**CITY OF FREDERICKSBURG
HISTORIC REVIEW BOARD**

AGENDA

Tuesday, January 9, 2018

CERTIFICATE OF APPROPRIATENESS APPLICATIONS

Application Number: 18-05
Date: January 9, 2018
Address: 305 S Bowie
Zoning: R1
Owner: Garry & Donna Francis
Applicant: Shayna Thompson
Rating: Low
Proposed Modifications: New 2 story addition with garage

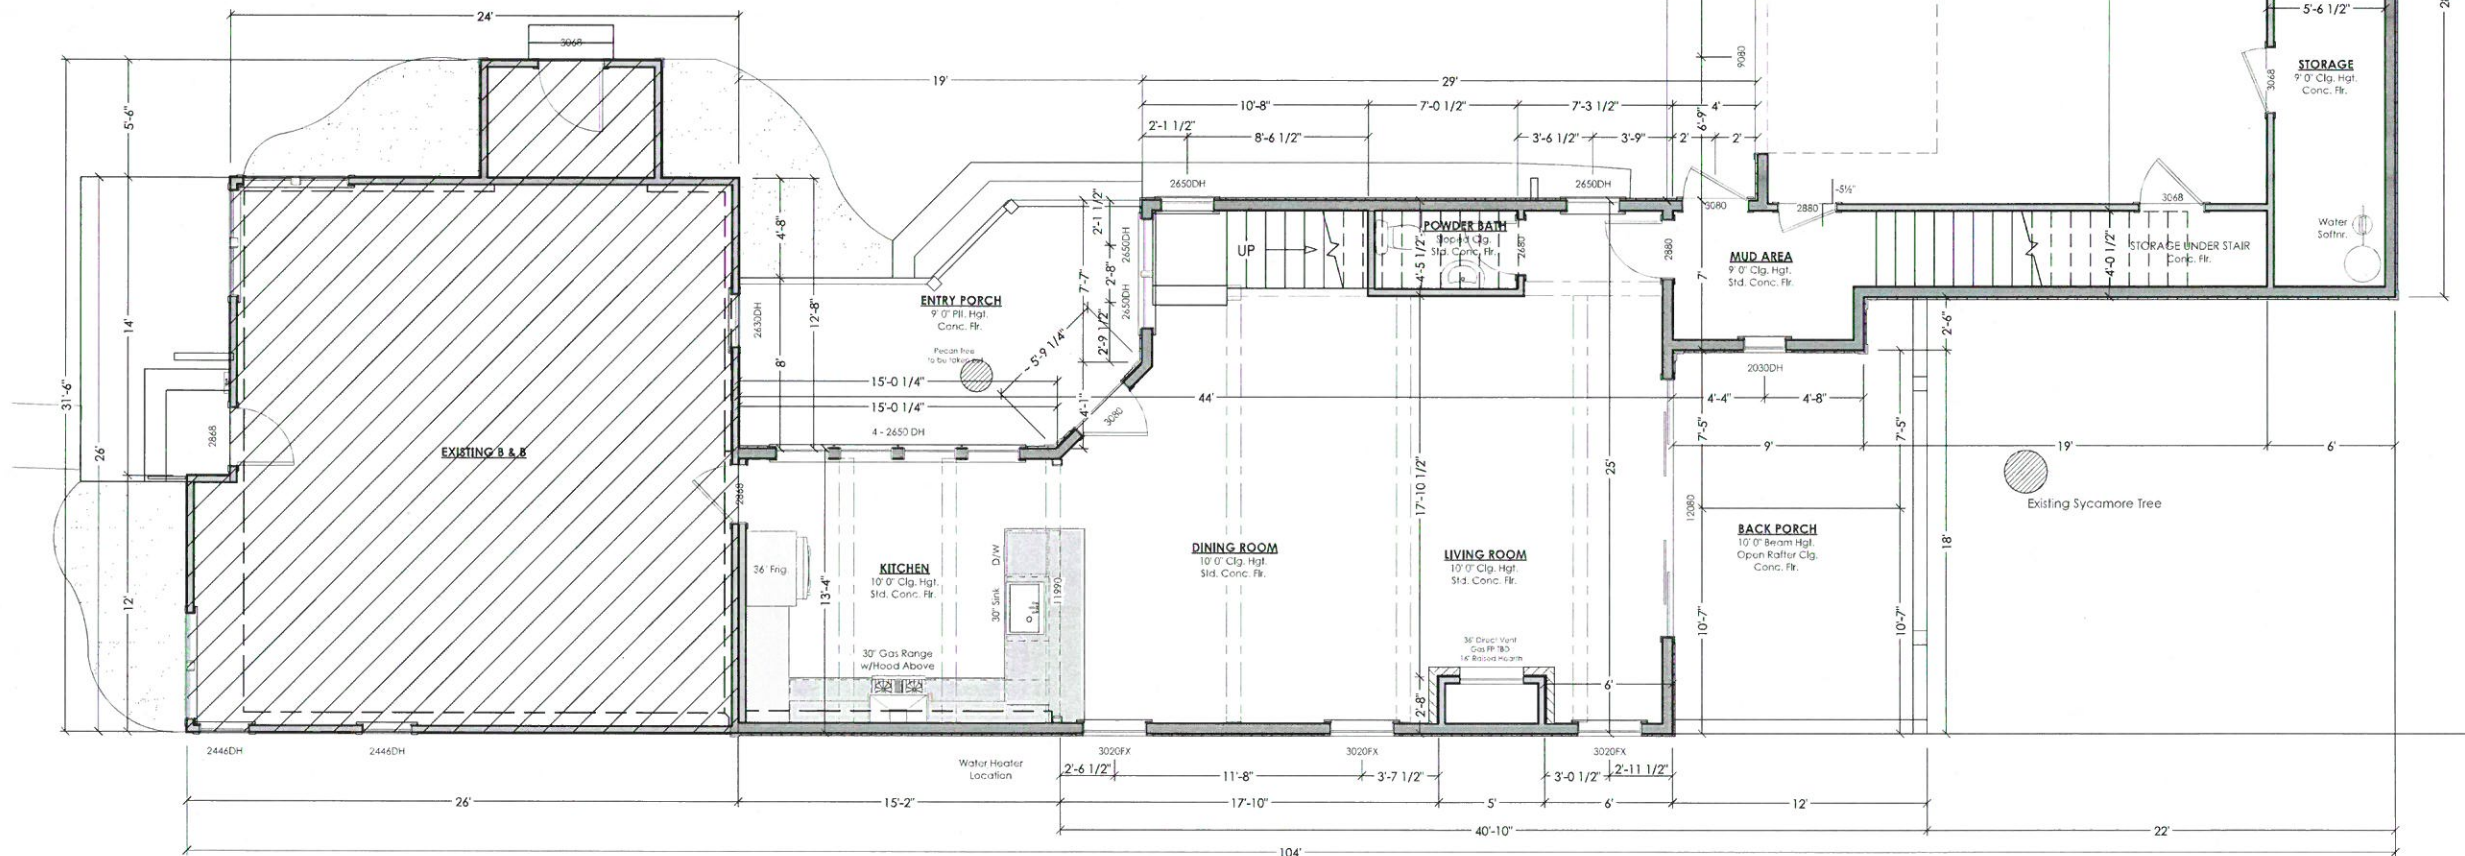
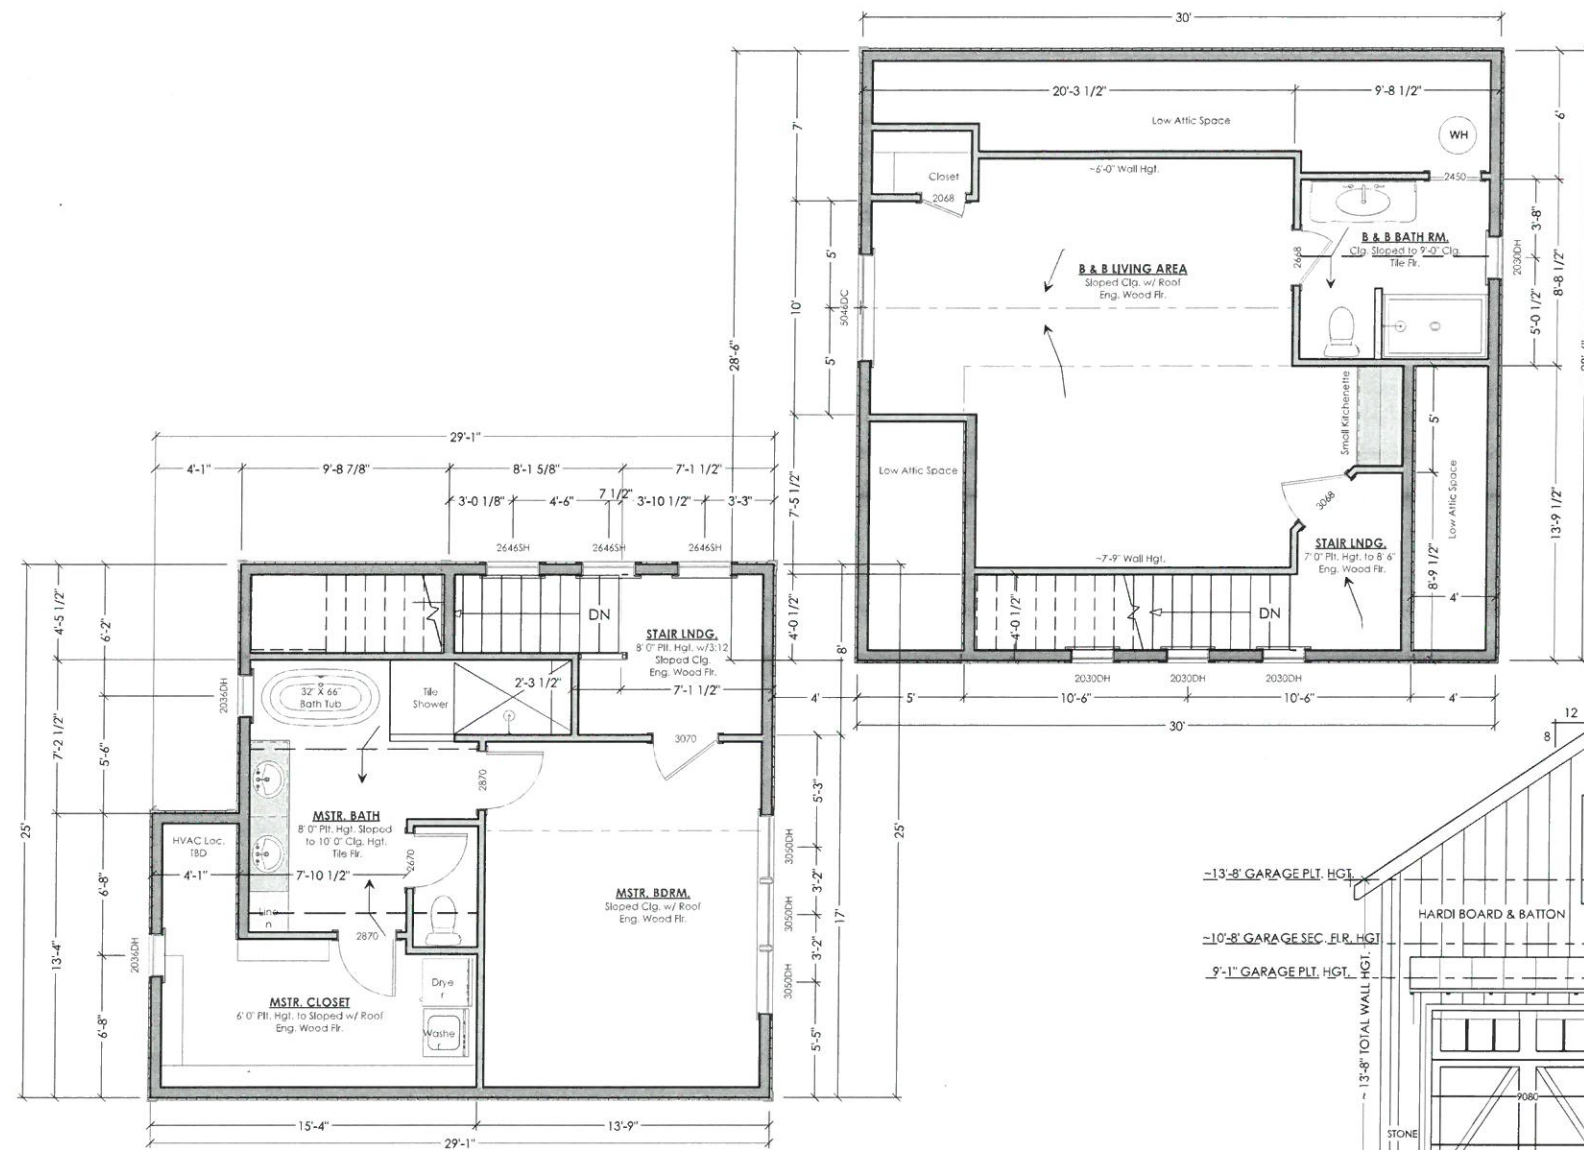
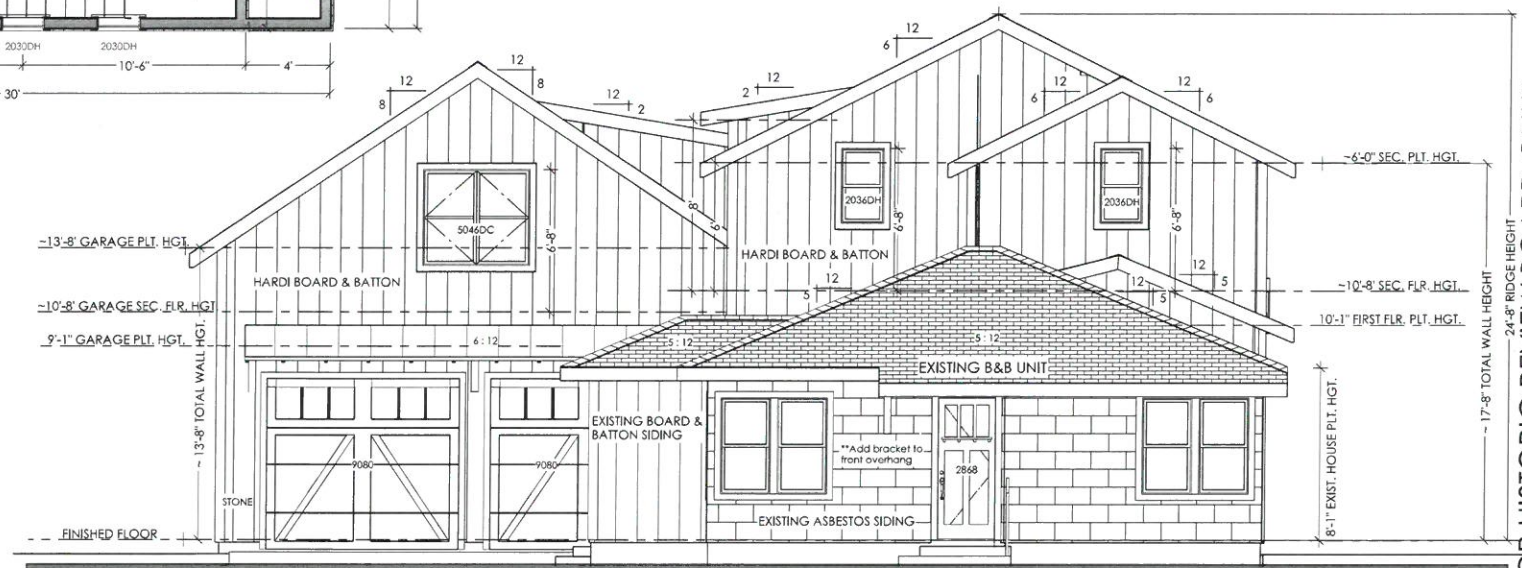
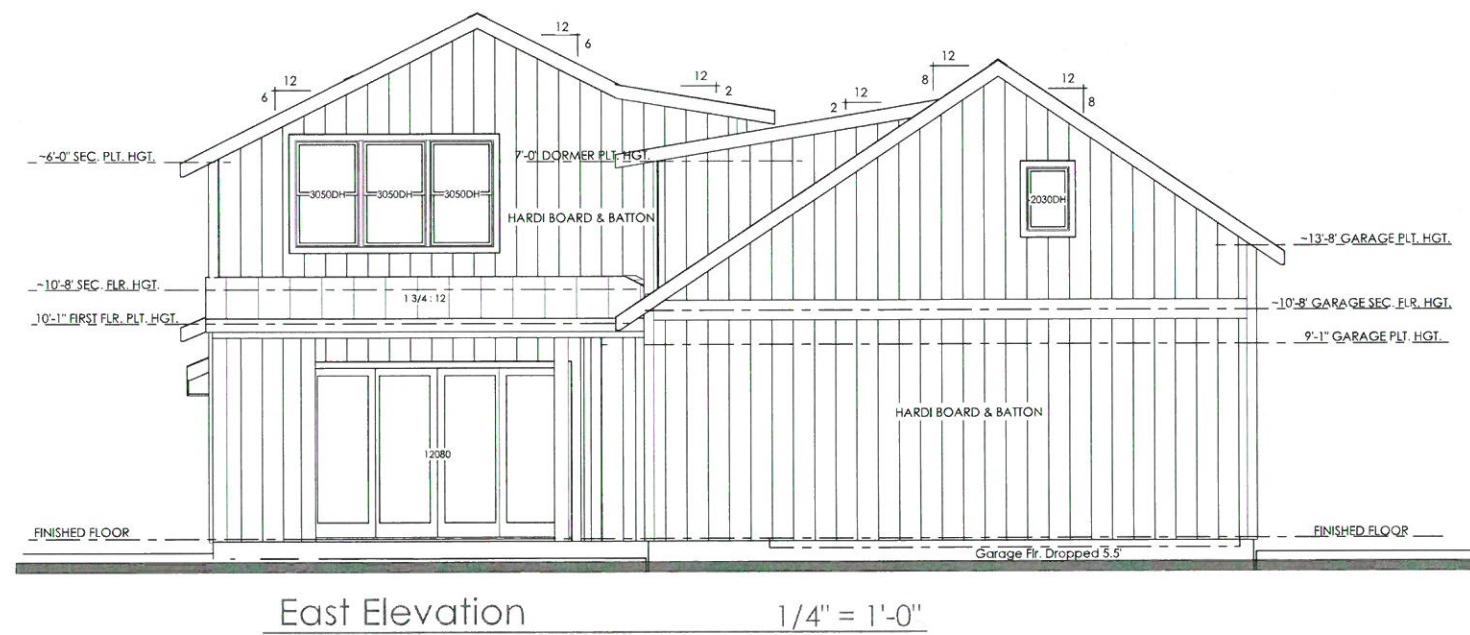
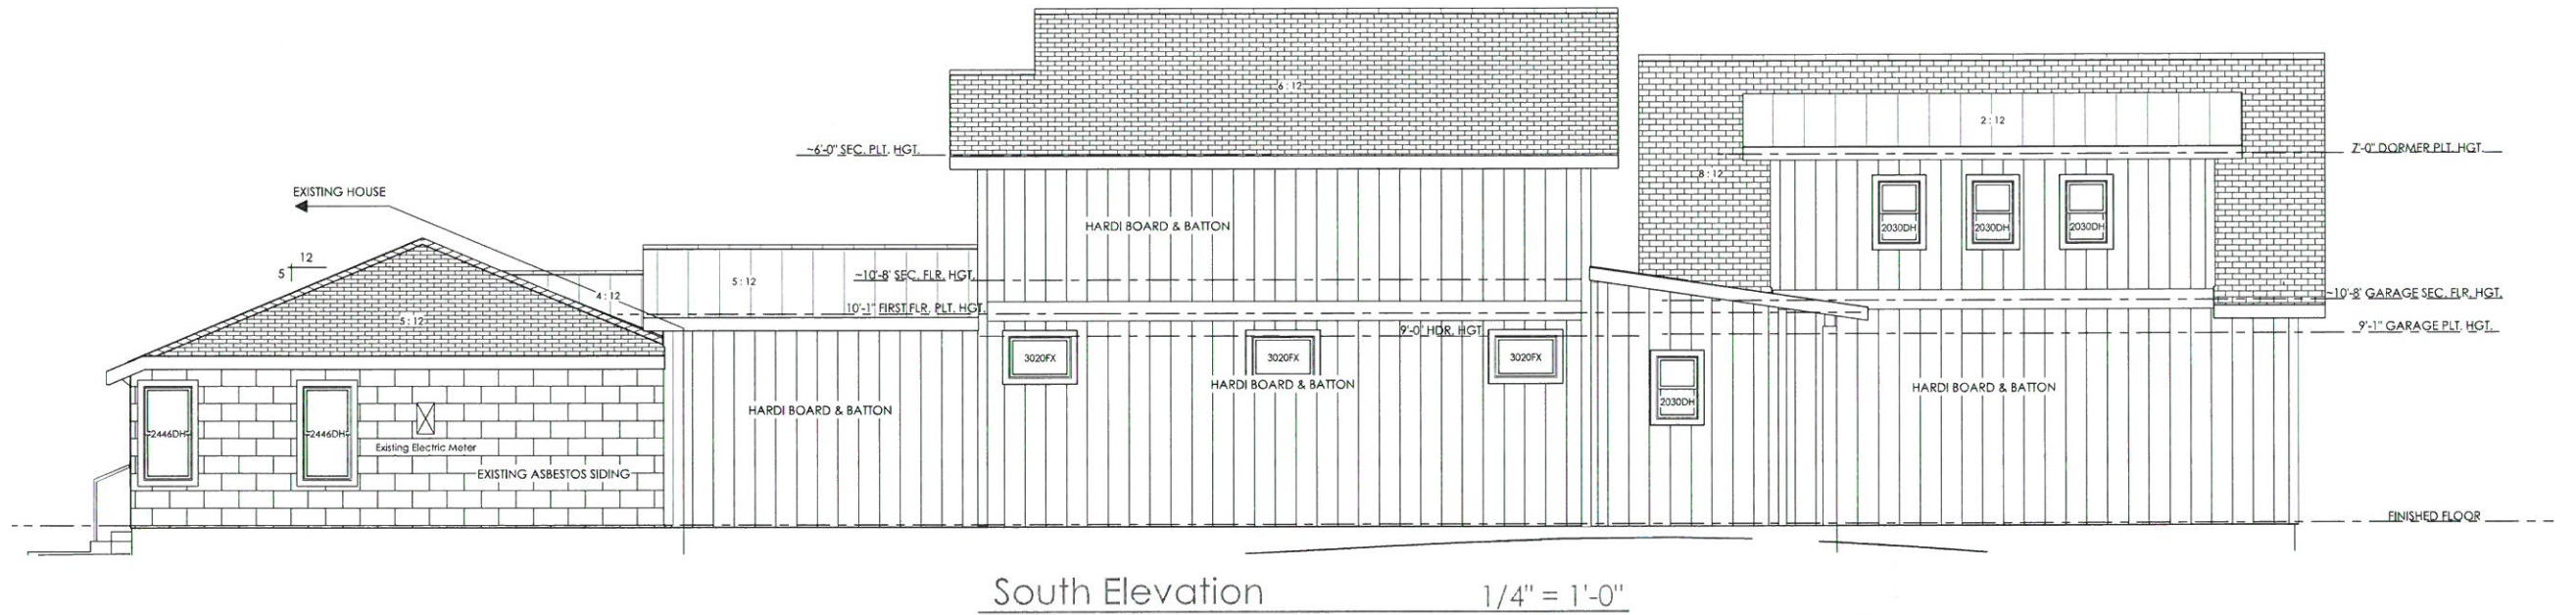
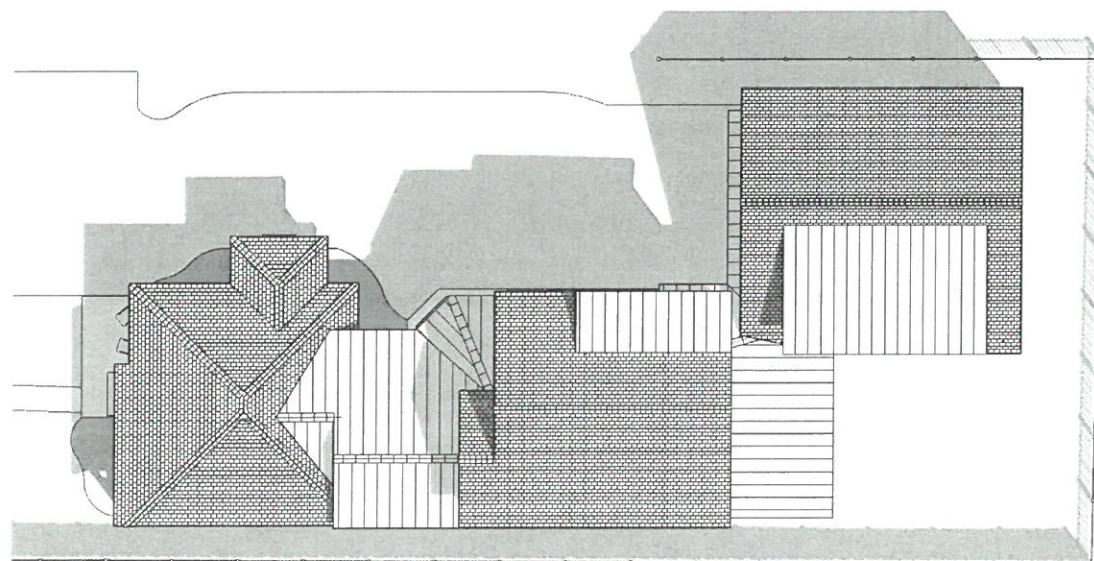
1. The proposed addition is appropriate in material and style, however the massing and scale overwhelm the small cottage. The applicant has tried to minimize the mass by using a one story connector, but new addition dominates the site. Staff does not recommend approval based on FBG Design Guidelines for new additions and new construction.
2. Staff recommends approval of the alterations to the existing house. The paint color is appropriate and the proposed bracket is a minimal design change to extend the life roof.
